**SUBJECT:** Prevent Inadvertent Rudder Trim Slipping During Extreme Deflections

**AFFECTED:** M20M: 27-0343, 27-0351, 27-0352, 27-0355 & ON  
M20R: 29-0412 & ON  
M20TN: 31-0002 & ON  
All Mooney M20U and M20V

**SERVICE INSTRUCTION SIM20-124**

**Date: April 12, 2018**

**Figure SIM20-124-1 - Rudder Trim Rigging**

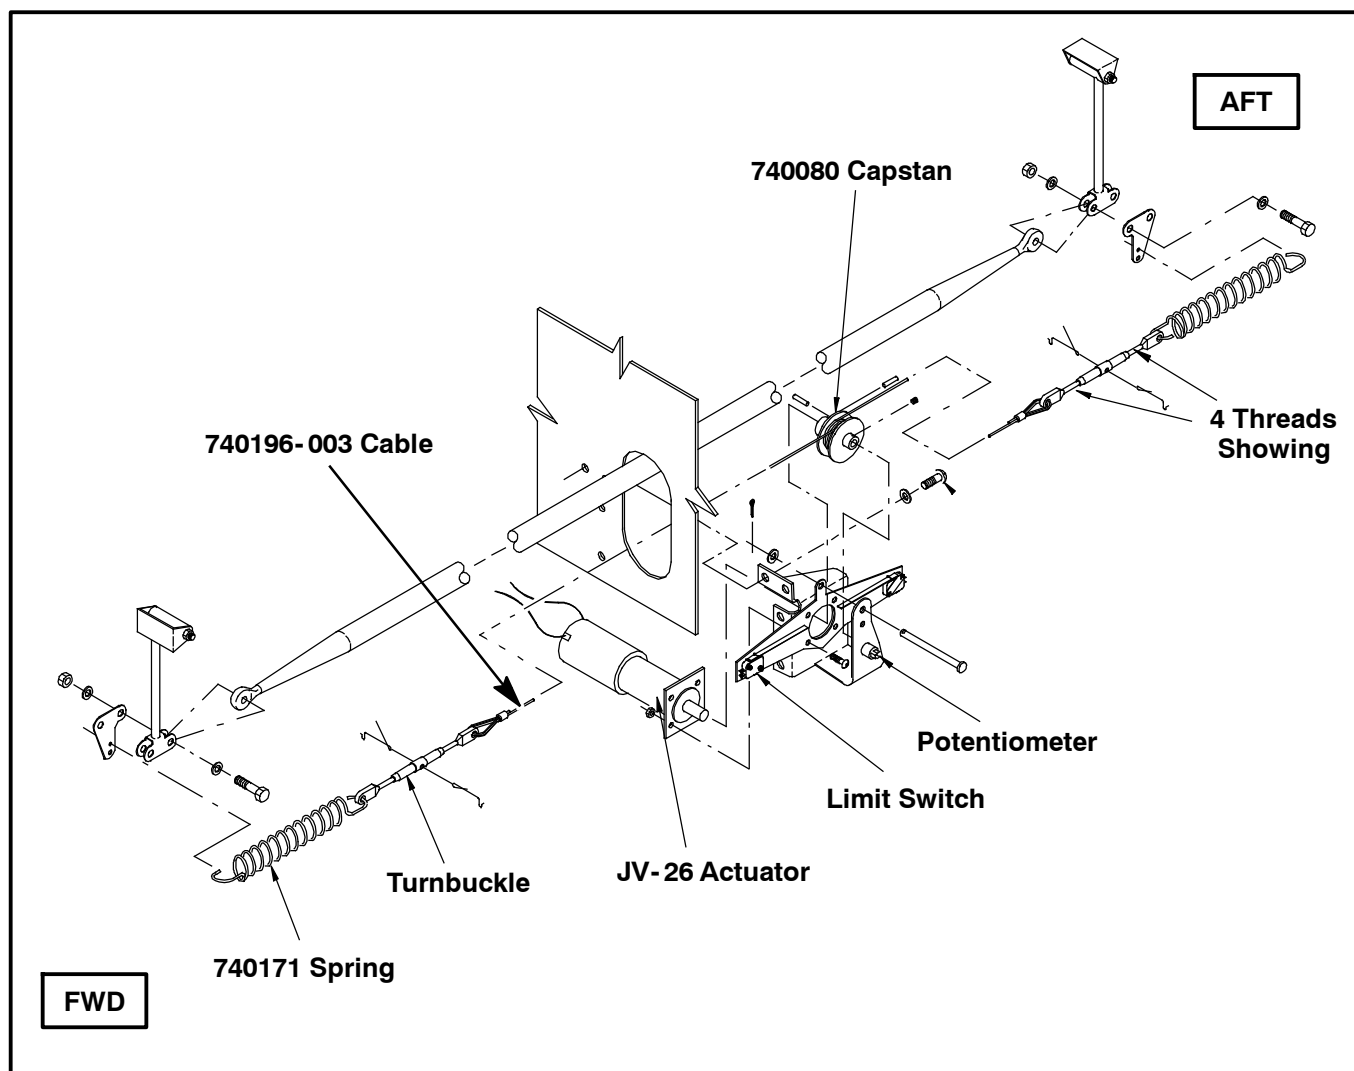
- 1.5. Wrap 740196-003 cable around 740080-001 capstan so that the forward eye of the 740196-003 cable is 10.75 inches from the forward surface of the 740080-001 capstan. Temporarily secure the cable using several wraps of a suitable tape around the cable and capstan. Install actuator assembly into the aircraft. Refer to Figure SIM20-124-1.
